Access Compliance Report

Public Rights-of-Way (Curb Ramps)

Intersection ID: 48410	Main Street: CAIRNS_MILL_CT	Cross Street: BELMAR_PLACE_RD	Location: SW
ADA ID: 3DC6878074A5	Ramp Type: PerpDiag	Initial Pass/Fail: Fail	Overall Compliance: No
Codes/Mitigation Info/Possible Solution		Field Measurements/Component Compliance	
Severity Score: 48.75

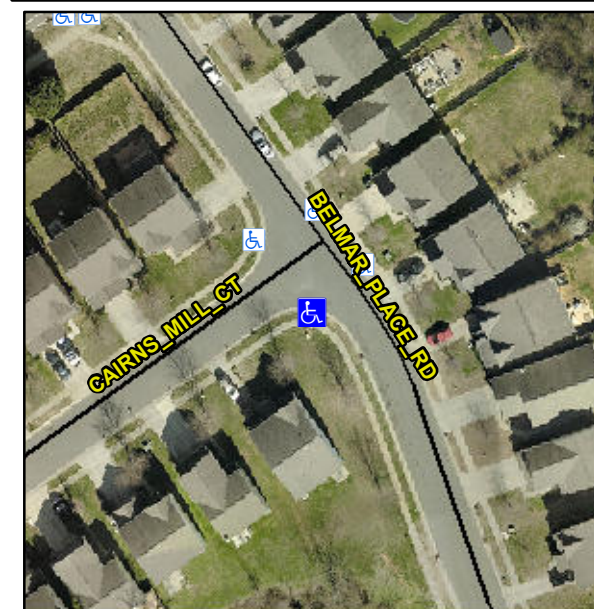
Not Found, R304.5.1, R304.2.2, R304.5.3

Compliance	Description	Data	Compliance	Description	Data
N/A	Ramp Length (in)	48.0	No	Ramp Slope (%)	11.8
No	Ramp Width (in)	31.0	No	Ramp XSlope (%)	3.6
N/A	Flare Type LT	N/A	N/A	Flare Type RT	N/A
N/A	Flare Slope LT (%)	N/A	N/A	Flare Slope RT (%)	N/A
N/A	Flare Traversable LT?	N/A	N/A	Flare Traversable RT?	N/A
N/A	Landing Length (in)	N/A	N/A	DWS Provided?	N/A
N/A	Landing Width (in)	N/A	N/A	DWS Contrast?	N/A
N/A	Landing Slope (%)	N/A	N/A	DWS Length (in)	N/A
N/A	Landing X Slope (%)	N/A	N/A	DWS Full Width?	N/A
N/A	Landing Curb? (Y/N)	N/A	N/A	DWS Offset (in)	N/A
N/A	Shared Landing?	N/A			
N/A	Gutter Ponding?	N/A	N/A	Gutter Slope (%)	N/A
N/A	Gutter Lip Ht (in)	N/A	N/A	Gutter X Slope (%)	N/A
N/A	Painted X Walk1?	No	N/A	Painted X Walk2?	No
	X Walk 1 Direction	To NE		X Walk 2 Direction	To NW
N/A	X Walk 1 Width (in)	N/A	N/A	X Walk 2 Width (in)	N/A
	X Walk 1 Slope (%)	1.8		X Walk 2 Slope (%)	3.2
	X Walk 1 X Slope (%)	3.9		X Walk 2 X Slope (%)	0.0

N/A	Ramp inside XWalk1?	N/A	N/A	Ramp inside XWalk2?	N/A
	Road Slope (%)	3.0	N/A	Clear Space?	N/A
	Road X Slope (%)	2.5	N/A	Clear Space to XWalk (in)	N/A
N/A	Any Obstructions?	N/A	N/A	Storm Grate/Utility Hazard?	N/A
	Obstruction Type			Storm Grate/Utility Type	
		N/A			N/A
			Yes	Surface Condition? (G/P)	Good

Remove & Replace Curb Ramp With Two New Directional Ramps or Equivalent.
